CERTIFICATE OF APPROPRIATENESS

Property: 4010 Pineridge St, Lot 14, Block 124, North Norhill Subdivision. The property includes a historic 1,868 square foot, one-story wood frame single-family residence and a detached carport situated on a 5,000 square foot (50' x 100') interior lot.

Proposal: Alteration – Construct a second-floor addition beginning 25'-11" from the front wall of the structure and a side addition to the previously constructed two-story addition at the rear.
See enclosed application materials and detailed project description on p. 4-18 for further details.

Recommendation: **Partial Approval: Denial to construct the second-story addition located on the original brick structure. Approval for all other proposed work.**

WEST ELEVATION – FRONT FACING STREET

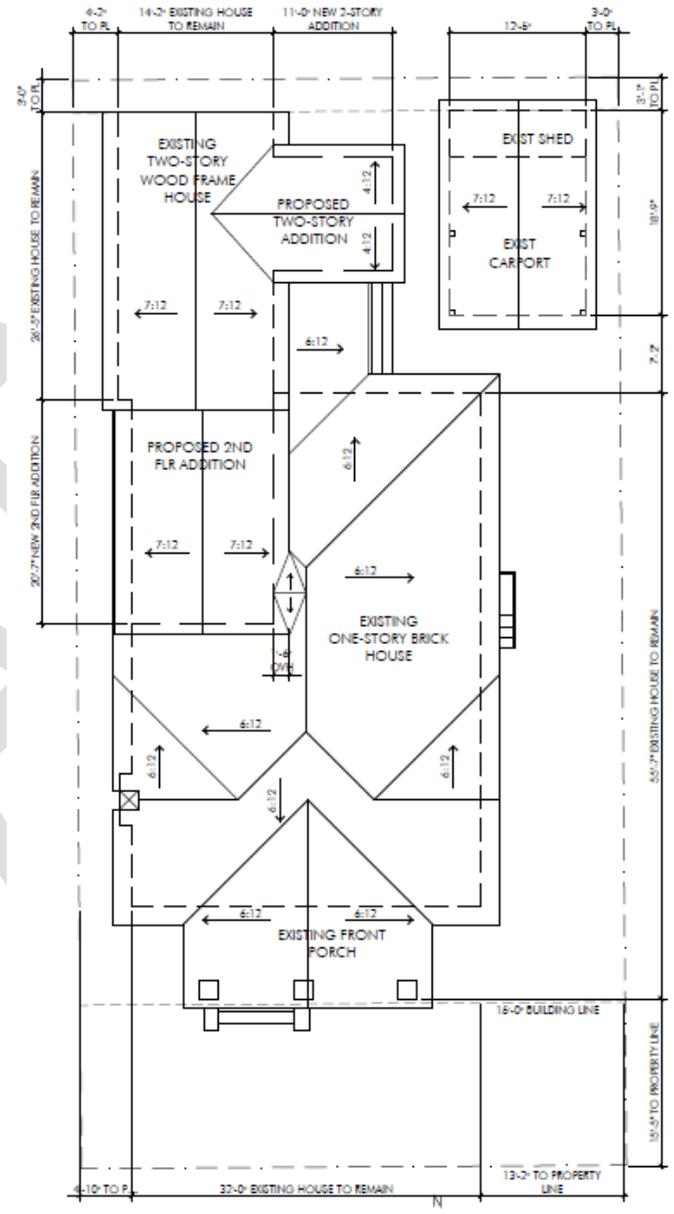
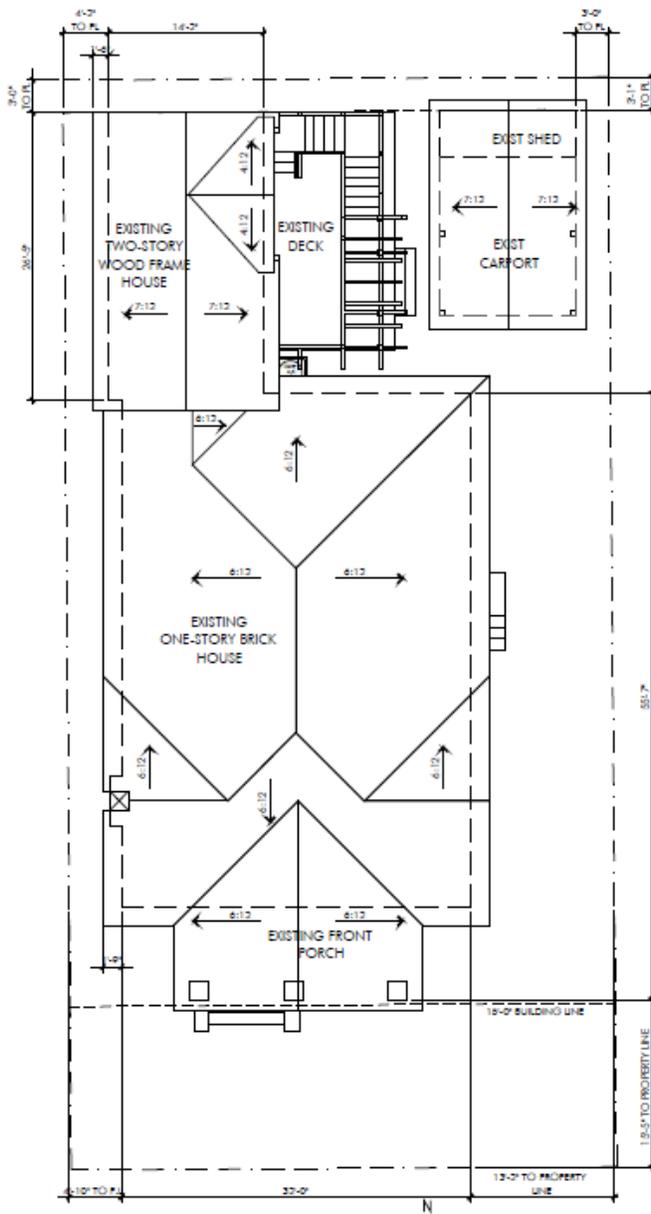
<i>The encroachment of the second-story addition onto the original structure does not retain the historical character of the property as a one-story structure.</i> |

<i>The second-story addition on the original structure alters the character of the structure as well as disrupts the rhythm of the blockface that contains all one-story bungalows due to its increased visibility from the street.</i> |

<i>The second-story addition on the original structure impairs the form and integrity of the house. The walls beneath will have to be reframed to carry the extra-load which results in the removal of interior shiplap as well as compromises the integrity of the brick cladding and original windows below.</i> |

<i>The original structure will have to be reframed which will destroy shiplap as well as compromise significant materials such as the windows and brick. The second story-addition also alters the form of the one-story bungalow and is not compatible with the one-story bungalows in the area.</i> |
